Consumers
Power
Company

DOCKET 50-255 - LICENSE DPR-20 -
PALISADES PLANT - RAPID RESPONSE
TO ADDITIONAL INFORMATION REQUEST
ON THREE MILE ISLAND

ATTACHMENT

Figure
4-3

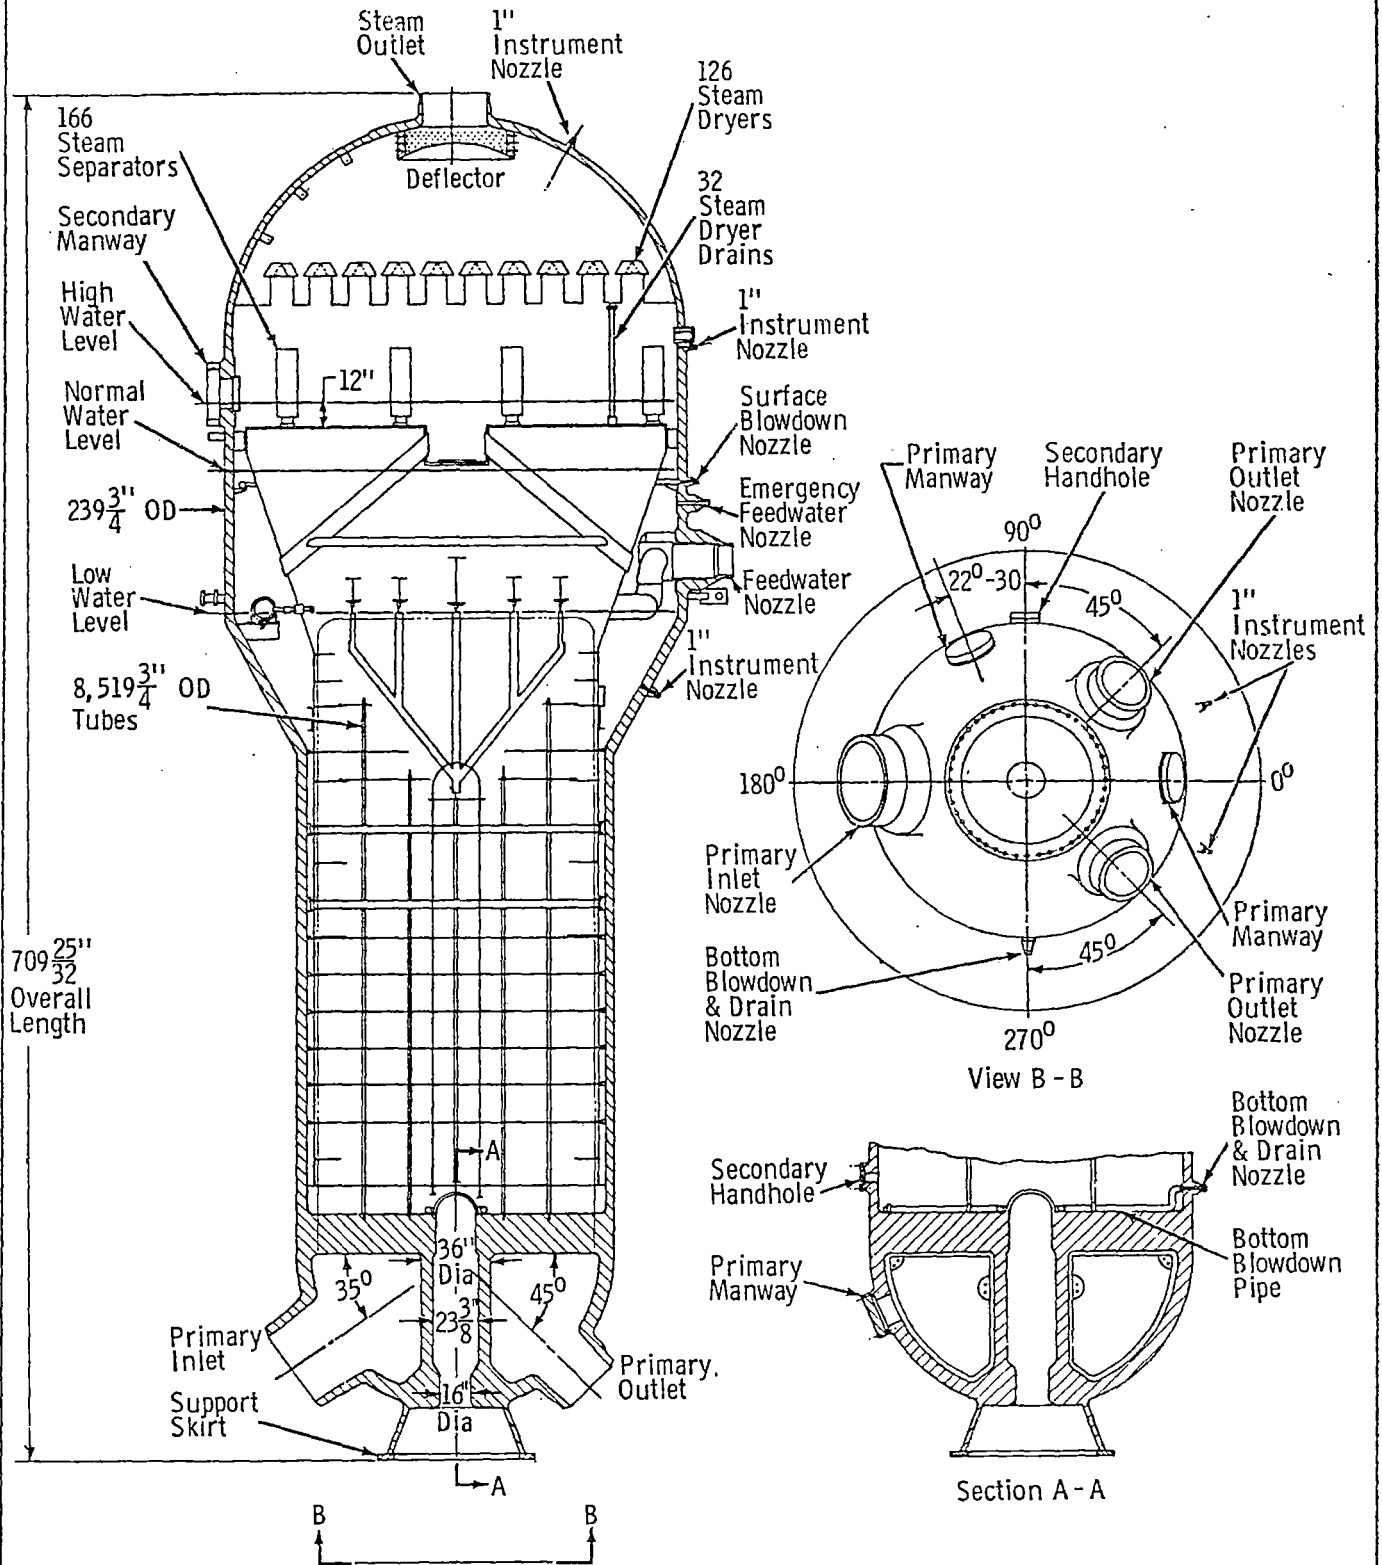
Provide a schematic diagram of the steam generator. Identify important characteristics. As a minimum provide the liquid level and volume for normal plant operation at power and the liquid level and volume at low level set point for reactor trip (for W plants low level with steam flow/feed flow mismatch) subsequent to a loss of feedwater. Describe the basis for this determination including a description and use of steam generator level span.

The attached prints and schematics provide the information requested. Water volumes and levels are as follows:

Normal: 382 11/16" above tube sheet, 5022 cu ft

Low Level Trip: 310 11/16" above tube sheet, volume not known
